# UNITED STATES PATENT AND TRADEMARK OFFICE

10/780,320

<b>Office Action Summary</b>	<b>Application No.</b> 10/780,320	<b>Applicant(s)</b> CAVENEY ET AL.	
	<b>Examiner</b> Philip Gabler	<b>Art Unit</b> 3637

## **DETAILED ACTION**

Ehrenfels '129 Figures 1, 2, and 5

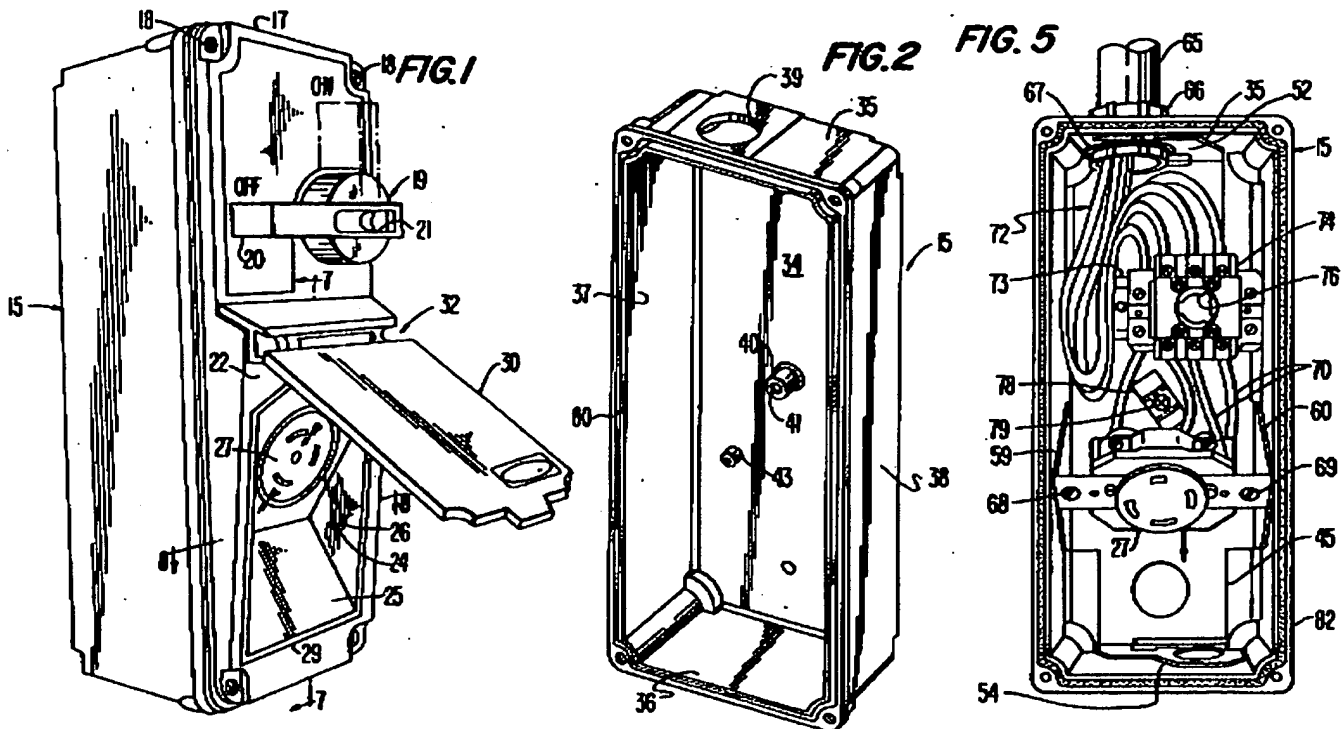
6. Claims 1 and 2 are rejected under 35 U.S.C. 102(b) as being anticipated by Ehrenfels (US Patent Number 5239129). Ehrenfels (Figures 1, 2, and 5) discloses a wall mountable cabinet comprising: a rear section (15 and 17) having a first end (top wall of 15) and a second end (bottom wall of 15), the rear section including a cutout area (39) adjacent the first end, wherein the cutout area allows access for cables to enter the cabinet; and a front section (30) hingedly connected to the rear section at a pivot point (32), wherein the cutout area is capable of allowing cables to rotate about the pivot point.

7. Regarding claim 2, Ehrenfels further discloses a duct (65) adjacent to the cutout area.

Thiede et al. '498 Figures 2-4

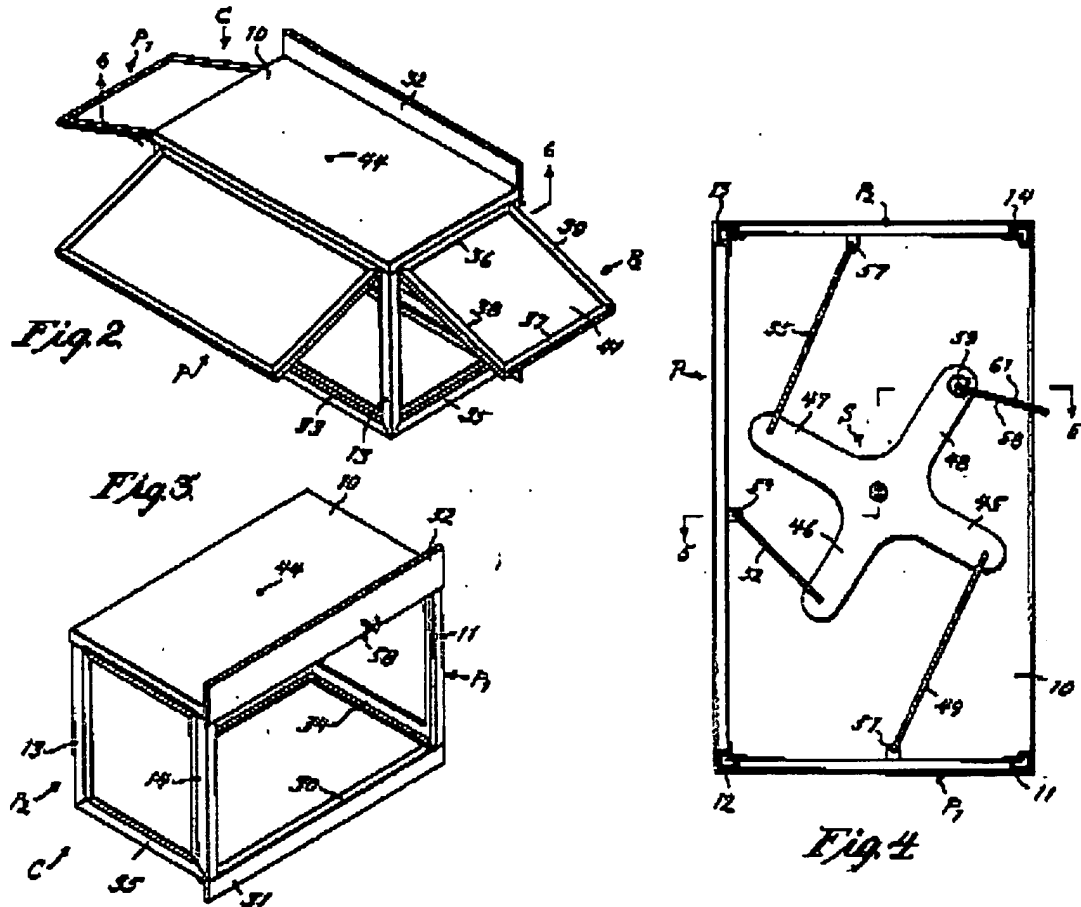
8. Claims 1 and 3 are rejected under 35 U.S.C. 102(b) as being anticipated by Thiede et al. (US Patent Number 3006498). Thiede (Figures 2-4) discloses a wall mountable cabinet comprising: a rear section (10, 11, 14, 31, and 32) having a first end (rear of frame 11, 14, 31, 32) and a second end (front of frame 11, 14, 31, 32), the rear section including a cutout area (space defined by frame 11, 14, 31, 32) adjacent the first end, wherein the cutout area is capable of allowing access for cables to enter the cabinet; and a front section (P) hingedly connected to the rear section at a pivot point (front edge of 10), wherein the cutout area is capable of allowing cables to rotate about the pivot point.

9. Regarding claim 3, Thiede further discloses two side access panels (P1 and P2) hingedly connected to the front section (through mechanism S and links 49, 52, and 55).

Exhibit 1: Hansson '362 Figures 1, 2, and 4

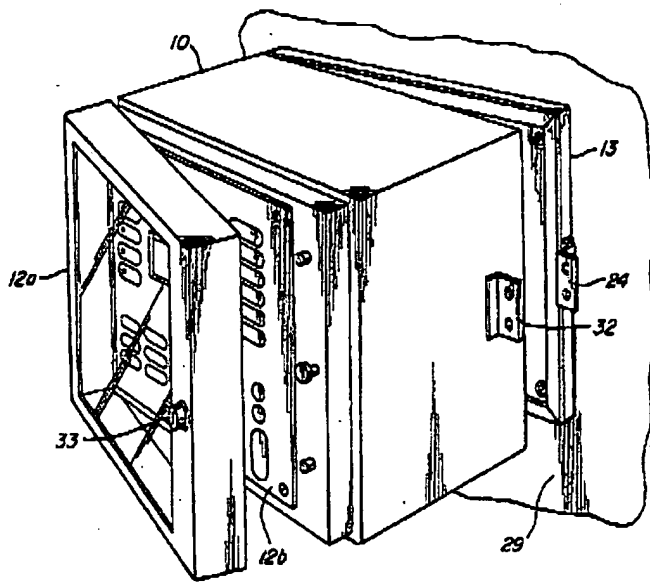
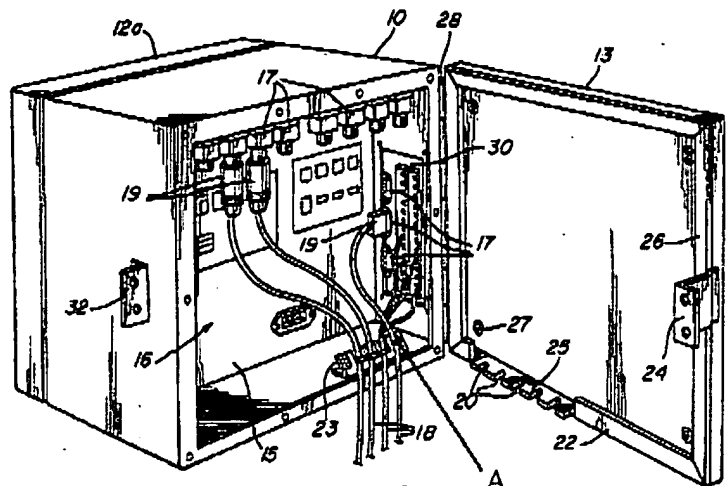
10. Claims 1, 4, 6, 7, 9, 11, 14, 17, 19, 20, and 23 are rejected under 35 U.S.C. 102(b) as being anticipated by Hansson (US Patent Number 5568362). Hansson (Figures 1, 2, and 4) discloses a wall mountable cabinet comprising: a rear section (13) having a first end (25, 26) and a second end (the remainder of rear section 13), the rear section including a cutout area (20) adjacent the first end, wherein the cutout area is capable of allowing access for cables to enter the cabinet; and a front

section (10) hingedly connected to the rear section at a pivot point (28), wherein the cutout area is capable of allowing cables to rotate about the pivot point.

11. Regarding claim 4, Hansson further discloses a front door (12a) hingedly connected to the front section (see Figure 1), wherein the front door includes a transparent window (see column1 lines 64-65).

12. Regarding claim 6, Hansson further discloses a slack cable manager (viewed as A in Exhibit 1) secured to a rail (23) mounted therein.

13. Regarding claim 7, Hansson further discloses a patch panel (30) secured to a rail (15) mounted therein.

14. Regarding claim 9, Hansson further discloses active equipment (17, 19) secured to a rail (15) mounted therein (via panel 30).

15. Regarding claim 11, Hansson discloses a wall mountable cabinet comprising: a rear section (13) having a cutout area (20); and a front section (10) hingedly connected to the rear section (through hinge 28), the front section having a cable management ring (A) secured thereon, wherein when the cabinet is in a closed position, the cable management ring is vertically aligned with the cutout area.

16. Regarding claim 14, Hansson further discloses a front door (12a) hingedly connected to the front section (see Figure 1), wherein the front door includes a transparent window (see column 1 lines 64-65).

17. Regarding claim 17, Hansson further discloses a patch panel (30) secured to a rail (15) mounted therein.

18. Regarding claim 19, Hansson further discloses active equipment (17, 19) secured to a rail (15) mounted therein (via panel 30).

19. Regarding claim 20, Hansson further discloses a first end (25, 26) and a second end (the remainder of rear section 13) of the rear section, the cutout area (20) being adjacent to the first end.

20. Regarding claim 23, Hansson further discloses the front section (10) hingedly connected to the rear section at a pivot point (28) adjacent to the cutout area and the first end of the rear section.

Nelson et al. '966 Figure 17

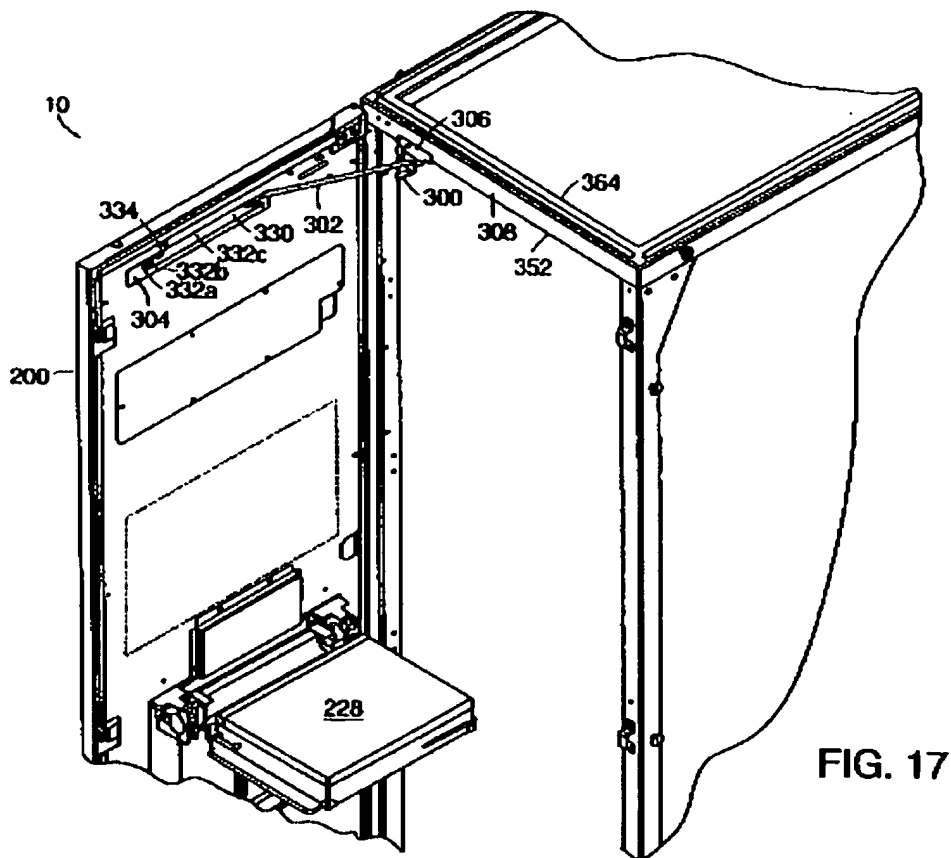
22. Claims 5 and 15 are rejected under 35 U.S.C. 103(a) as being unpatentable over Hansson in view of Nelson et al. (US Patent Number 6061966). Hansson discloses a wall mountable cabinet as recited in claims 1 and 11 but does not disclose a rod which maintains the front section in an open position. Nelson (Figure 17) discloses a cabinet comprising a rod (302) which maintains the front section (200) in an open position about 90 degrees from the rear section (308). Accordingly, it would have been obvious to one of ordinary skill in the art at the time the invention was made to modify Hansson's cabinet to include a rod to maintain the front section in an open position as taught by Nelson because this arrangement would facilitate access to Hansson's cabinet by providing a prop for the front section.

English et al. '233 Figure 1

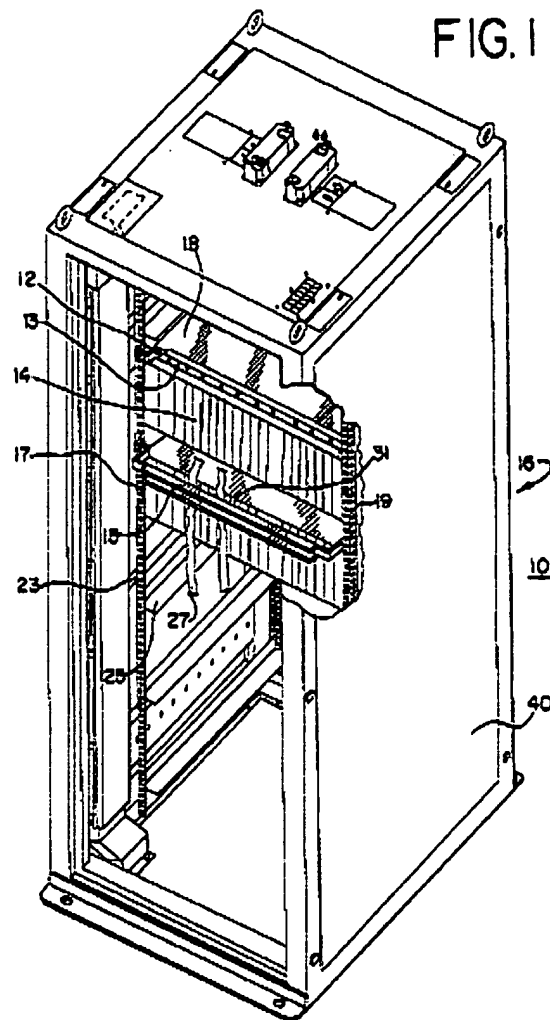
23. Claims 8, 10, 16, 18, and 22 are rejected under 35 U.S.C. 103(a) as being unpatentable over Hansson in view of English et al. (US Patent Number 6067233). Hansson discloses a wall mountable cabinet as recited in claims 1 and 11 but does not disclose a horizontal cable manager secured to a rail. English (Figure 1) discloses a bar (12) mounted to a rail (17) intended for both cable management use and mounting of electronic modules (see column 3 lines 59-62) and that is capable of supporting a slack cable manager, horizontal cable manager, patch panel or active equipment as is known in the art. Accordingly, it would have been obvious to one of ordinary skill in the

art to modify Hansson's cabinet to include a cable manager or electronic component mount secured to a rail system as taught by English because this arrangement would provide more versatility to Hansson's cabinet while maintaining organization.

24. Regarding claims 10 and 22, Hansson discloses a wall mountable cabinet as recited in claims 4 and 14 but does not disclose an adjustable rail. English discloses a rail (12) that can be adjusted (via holes 23) to various positions within a cabinet (10).

Accordingly, it would have been obvious to one of ordinary skill in the art at the time the invention was made to modify Hansson's cabinet to include an adjustable rail as taught by English because this would allow greater flexibility as to what could be mounted in his cabinet.

Erickson '319 Figure 1

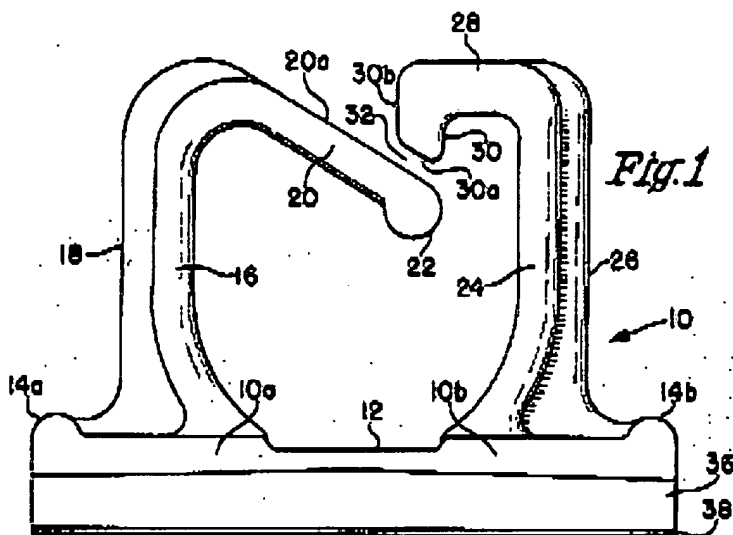
27. Claims 21 and 24, as best understood, are rejected under 35 U.S.C. 103(a) as being unpatentable over Hansson in view of Erickson (US Patent Number 3659319). Hanson discloses a wall mountable cabinet as recited in claim 11 but does not disclose a cable management ring with substantially L-shaped arms. Erickson (Figure 1) discloses a wire management clip with first (16 and 20) and second (24 and 28) substantially L-shaped arms having distal portions (20 and 28) oriented substantially 90 degrees from substantially linear portions (16 and 24), wherein the arms are formed of a material and construction capable of providing rotation (i.e. plastic; see column 2 lines 17-18) about the axis of their linear portions. Accordingly, it would have been obvious to one of ordinary skill in the art at the time the invention was made to modify Hansson's cable management ring to include substantially L-shaped arms as taught by Erickson

because this arrangement would make securing and removing cables from the ring more efficient.
